**In the Drawings**

**REMARKS**

David B. Ritchie  
Thelen Reid & Priest LLP  
Express Mail: EV310857706US  
TRP Docket No.: IMPJ-0027A

Figure 19

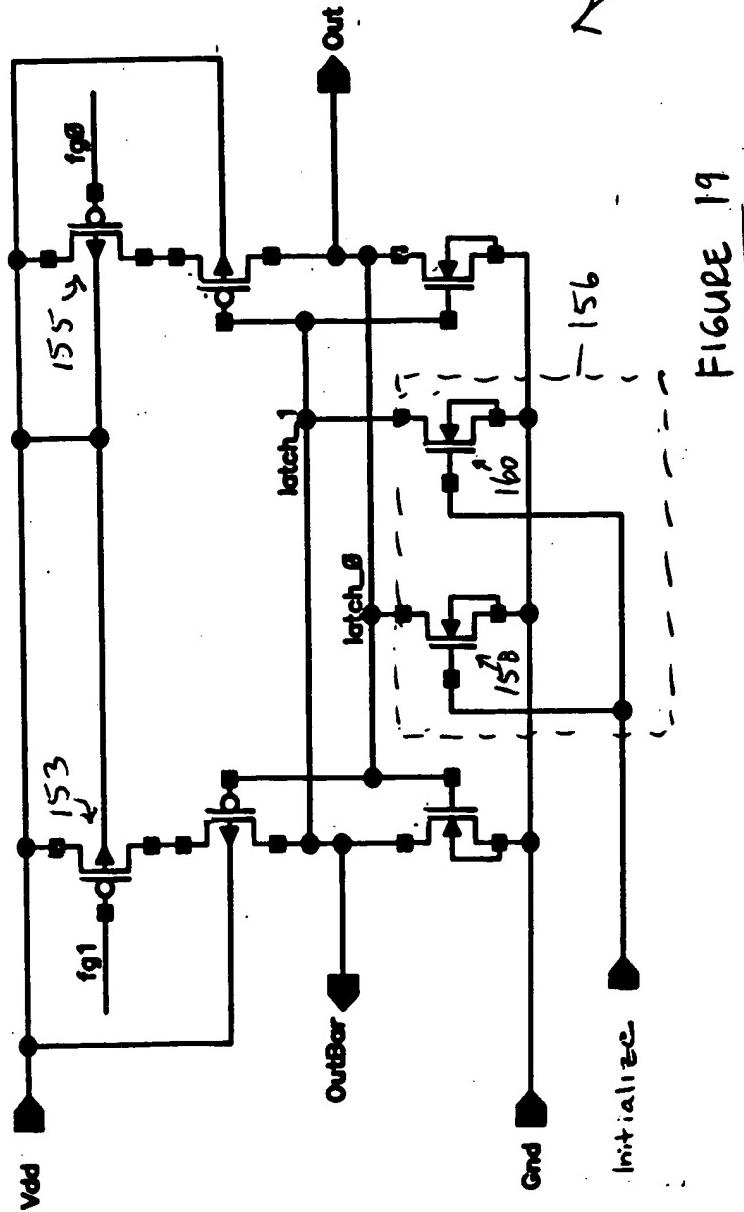
FIG. 19 has been amended to add the designations 153 and 155.

FIGURE 12B

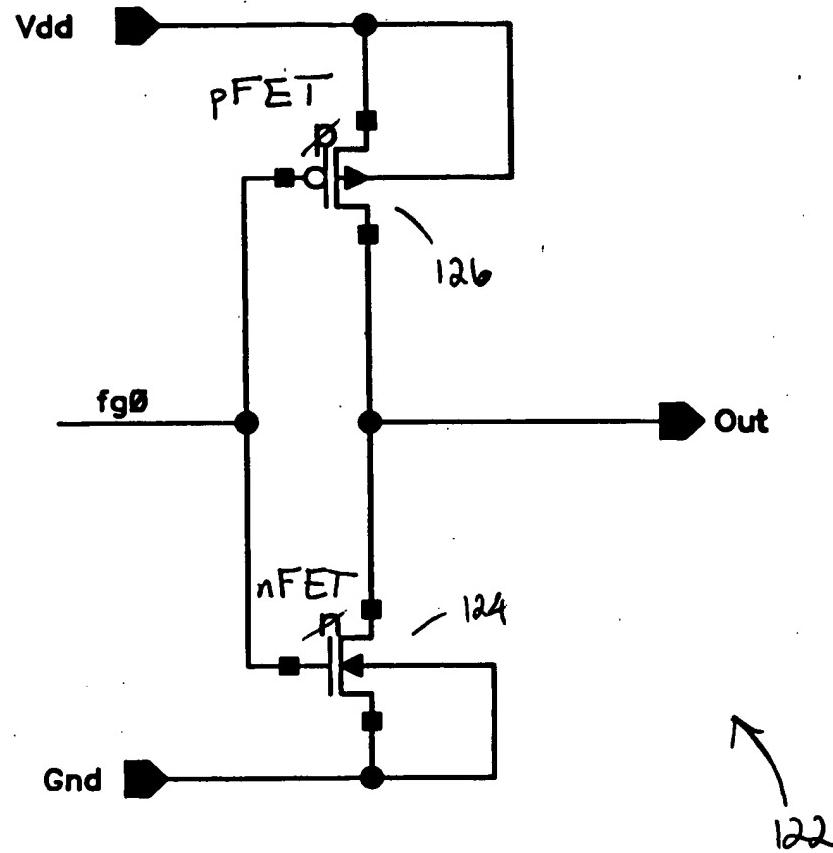
FIG. 12B has been amended to add the designations pFET and nFET.
